## County of San Mateo

### Contract Amendment Coversheet and Contract Amendment for

**AMENDMENT 29 TO AGREEMENT R080465  
BETWEEN THE COUNTY OF SAN MATEO AND  
TRUEBECK CONSTRUCTION, INC.**

**PCCO #5177.2–Truebeck #CE: #5177.2: RAB COR 08  
Public Circulation (Early Work) Signage Footings**

## SW Signage Clarification

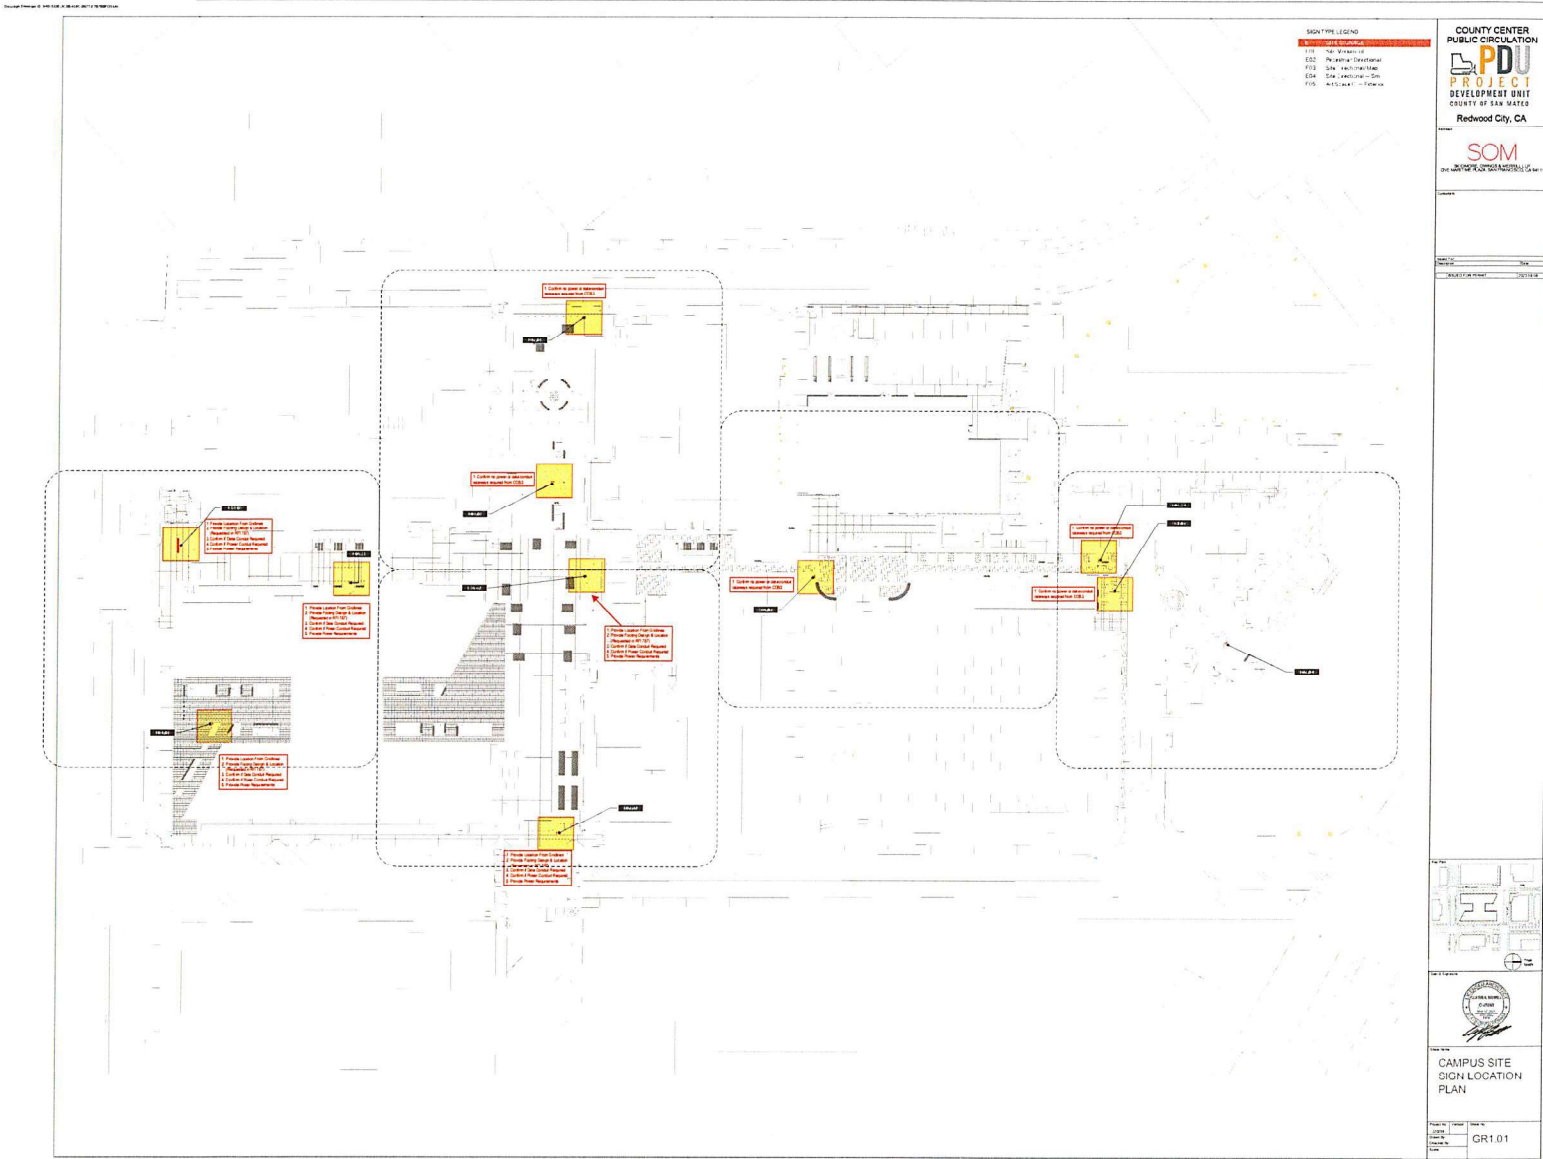
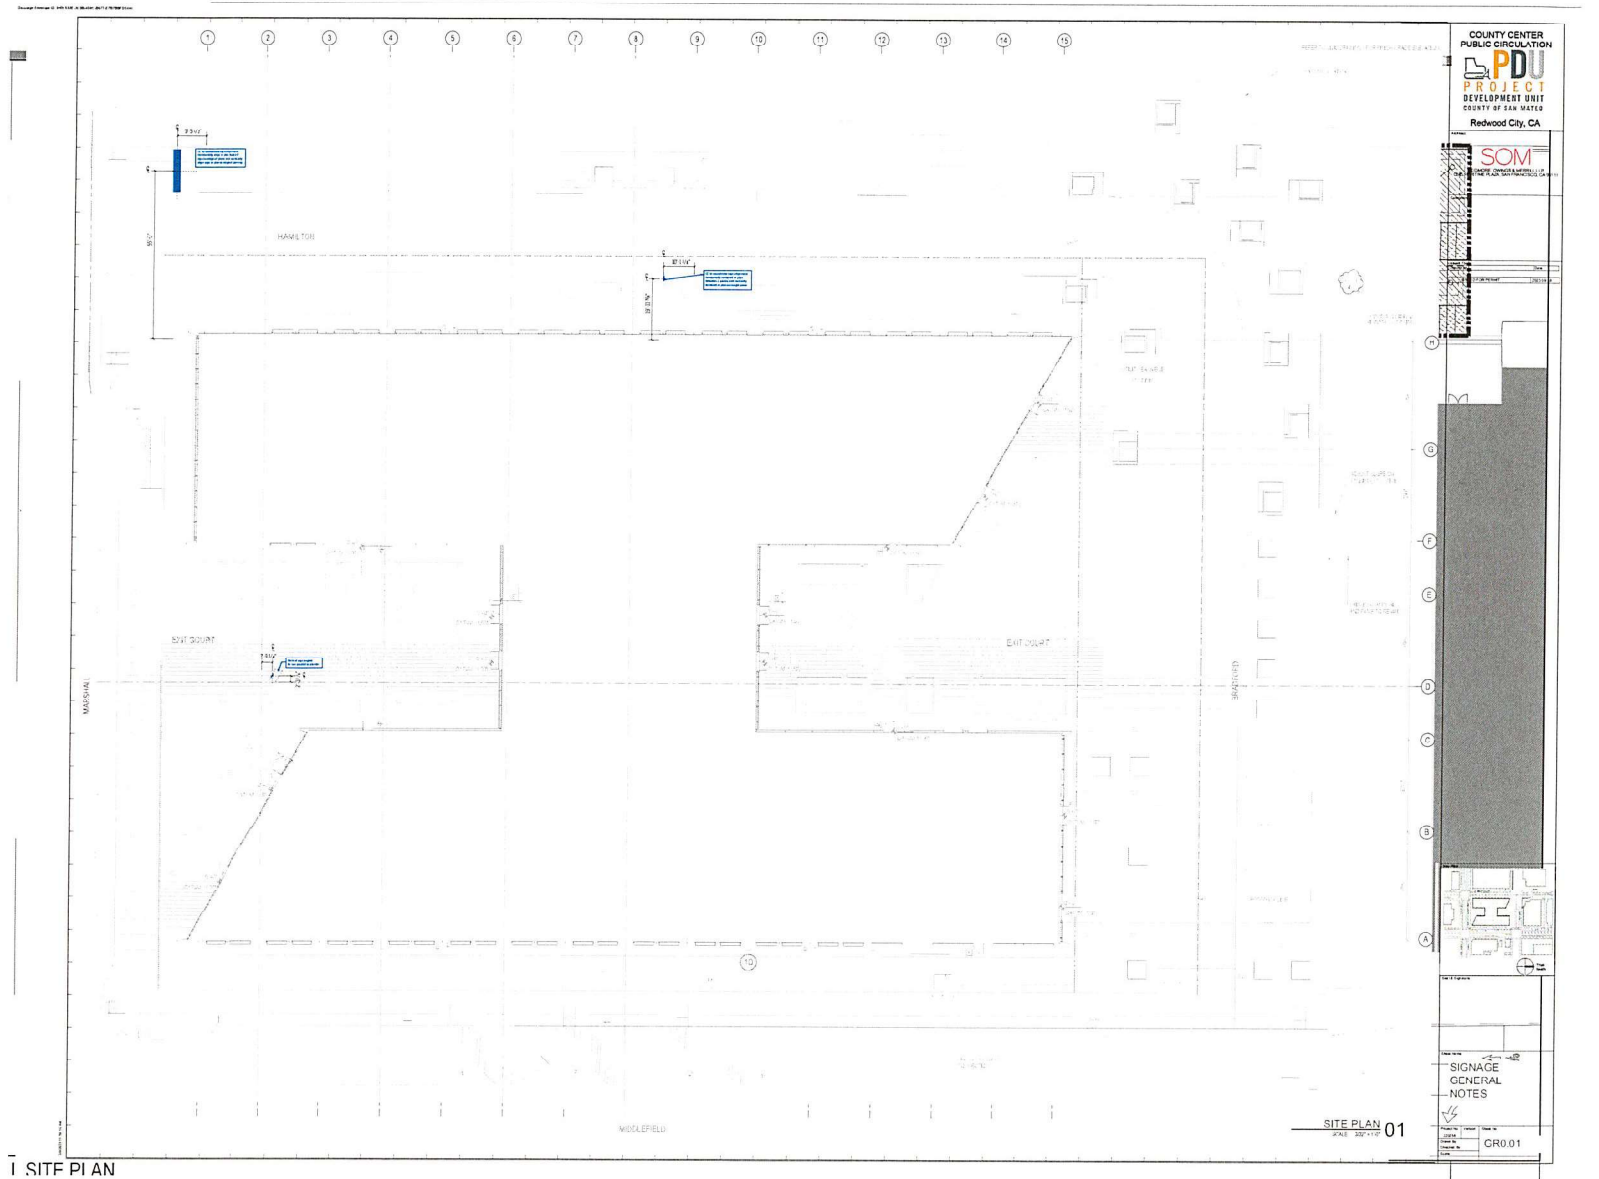
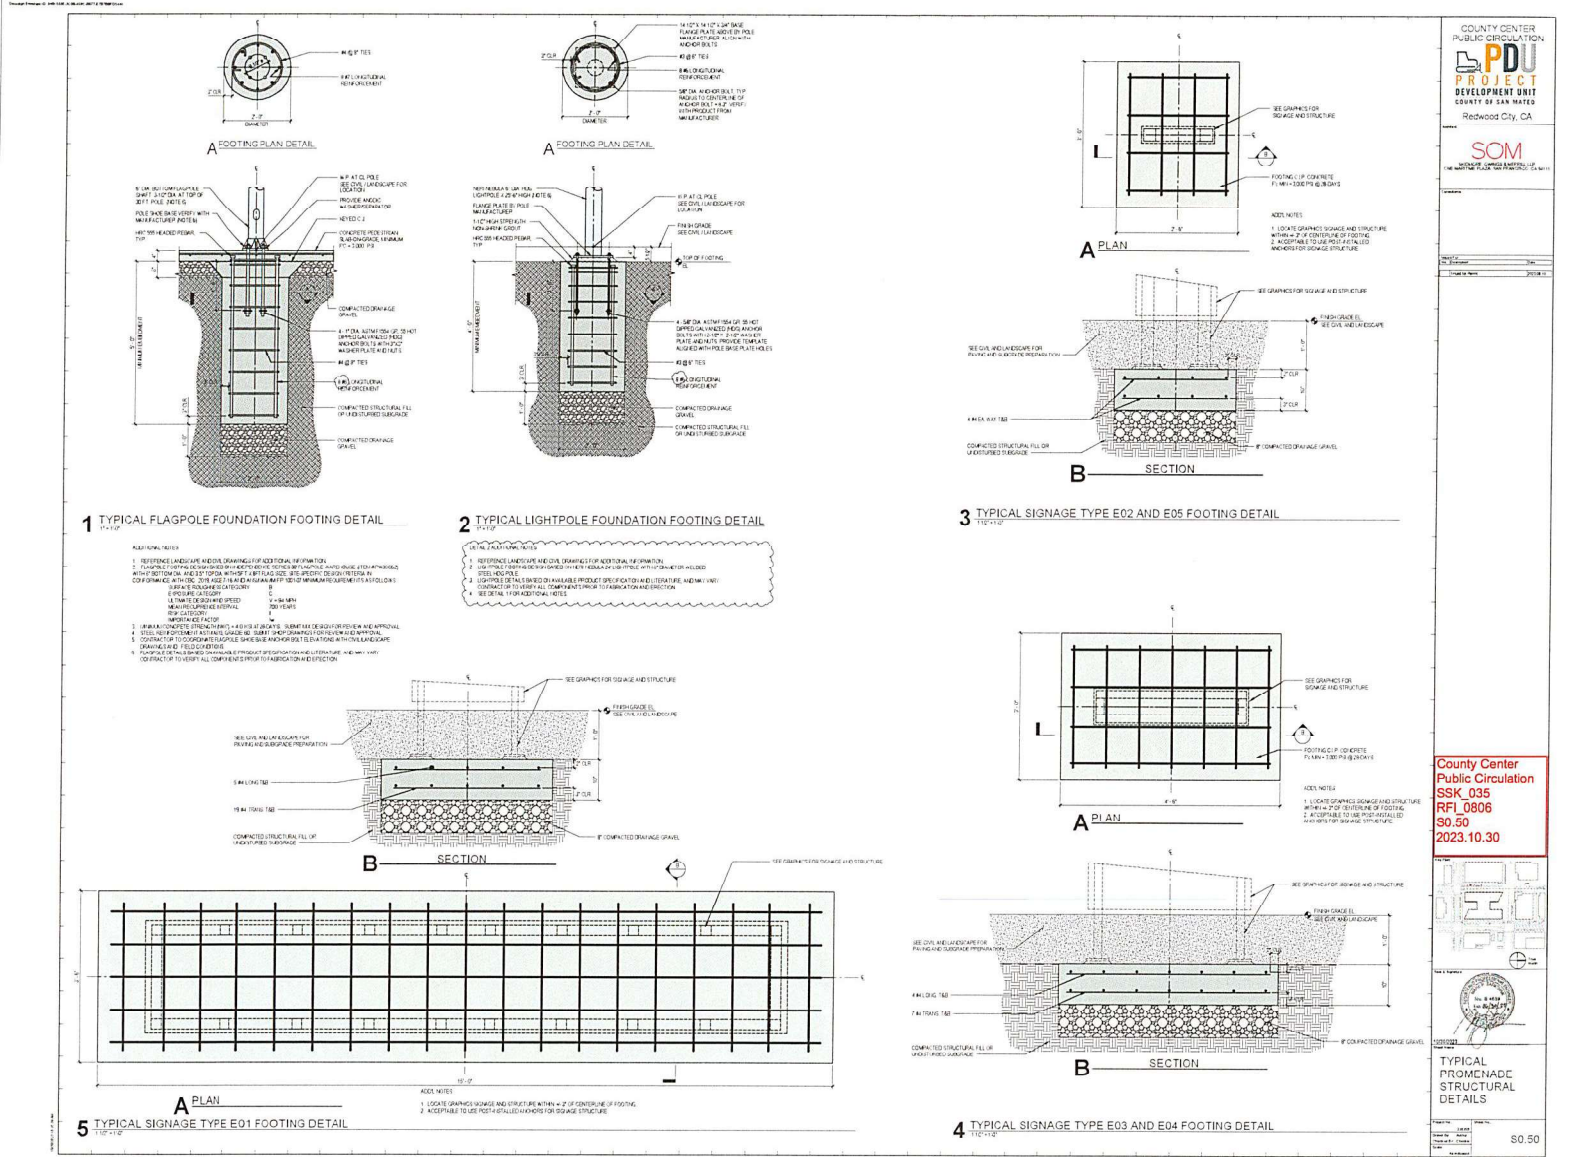
Please provide requested information as shown on attached mark up regarding electrical and footing needs for the future signage that is part of the Public Circulation scope

Per the County Center Public Circulation Drawings, only sign locations E04.01 and E03.01 will require data and electrical power connections. Per Owner direction, only electrical power will be needed for sign location E01.01 for exterior lighting. Therefore, 3 signs total will require power. Out of those 3, 2 will need data connections. Refer to Technology PC.T1.00 and PC.T1.01, and Electrical Drawing E1.0.

For footing placements for 3 sign locations within the COB3 building area within hardscape (as discussed 10.27.2023) for coordination, see attached location plan with locations dimensioned from guidelines as requested. Final location of all signs and lights to comply with documented alignments per sheet GR2.01.

Provide CCPC graphic signage footings per attached SSK-035 Details 3, 4 & 5 / S0.50 (file: 20231030 - COB3 - SSK\_035 RFI\_0806 S0.50.pdf).

2023-10-30, TECI: To finalize sign E01.01 location, Contractor to confirm that the existing push button, pole and traffic signal are being removed and relocated as noted in Encroachment Permit Hexagon drawing E-1, project note 3 and Pole location. All sign locations shall have existing utilities potholed or located to verify depth and horizontal location and information sent to design team for review.
